SERVICE BULLETIN

No. SB17-067

Subject:	The countermeasure against the internal oil leakage of the “VALVE ASSEMBLY-OIL CONTROL”
Applicable part category in service manual:	Engine>FUEL INJECTION (FUEL SYSTEMS)(H4DO) > Oil Control Solenoid
Applicable Parts name in Subaru Fast:	“VALVE ASSEMBLY-OIL CONTROL”
Foreword:	This service bulletin is to inform you of the countermeasure part against the internal oil leakage of the “VALVE ASSEMBLY-OIL CONTROL” of the FB/FA engine.

2-1 Detail of the Symptom.

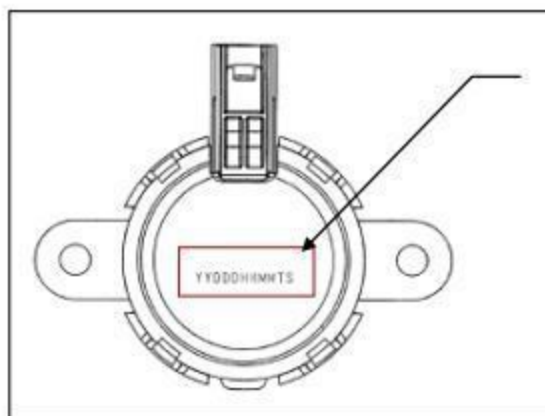
Symptom	Details
The some certain vehicles may have an oil contamination on the connector of the “VALVE ASSEMBLY-OIL CONTROL”.	The cause may be the internal oil leakage from the oil seal; of the “VALVE ASSEMBLY-OIL CONTROL”. The countermeasure part has a new oil seal.
